2020-2024MY
Telluride (ON)

125 (Rev 1, 09/20/2024)

TECHNICAL SERVICE BULLETIN

SELF-LEVELING REAR SHOCK ABSORBER
INSPECTION/REPLACEMENT (WTY040)

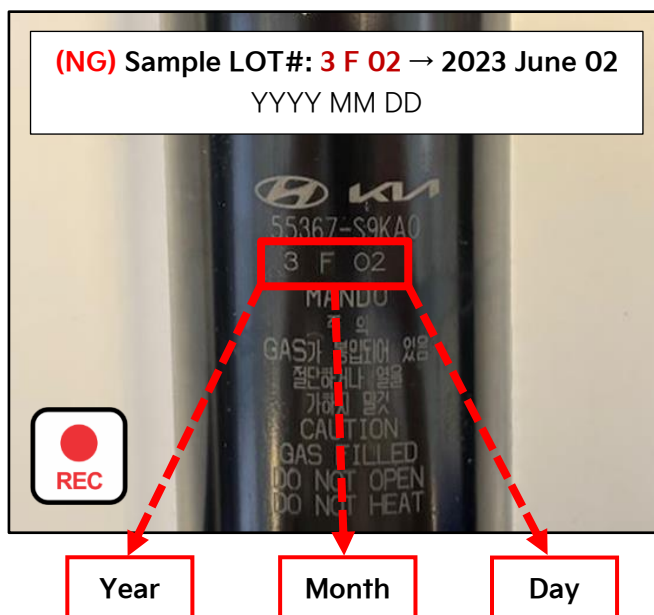
2. Inspect both (LH & RH) 'self-leveling' rear shock absorber LOT#s (Refer to the LOT/DATE conversion table below):

- Produced 'on or after' 3 F 05
(2023 June 05) (OK), then this publication 'Warranty Extension' is not applicable to the inspected shock absorber. Claim Op Code: 242A3510
- Produced 'on or before' 3 F 04
(2023 June 04) (NG), then take a KVID video starting from the VIN label on the door and then move to capture the LOT number stamped on the affected rear shock absorber, and then proceed to step 3 to replace the affected LH and/or RH rear shock absorber.

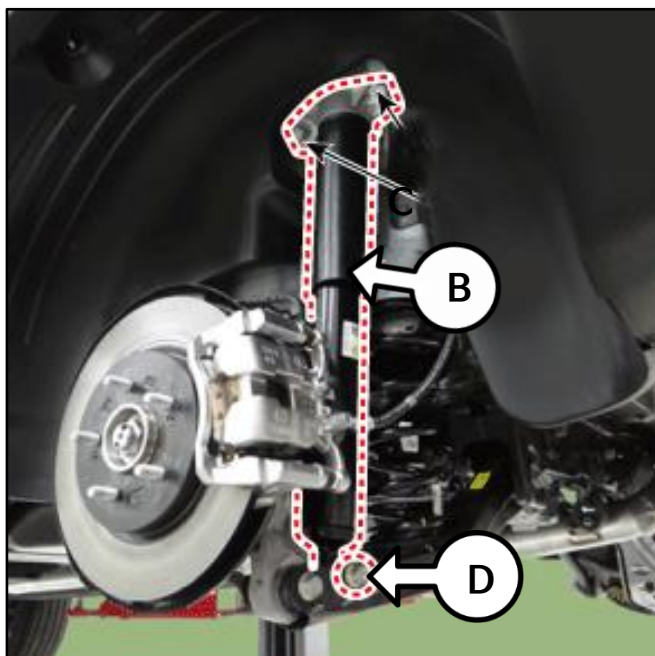
Note: Install a 'new' self-locking nut (C) when replacing the rear shock assembly. The bottom nut (D) is reusable.
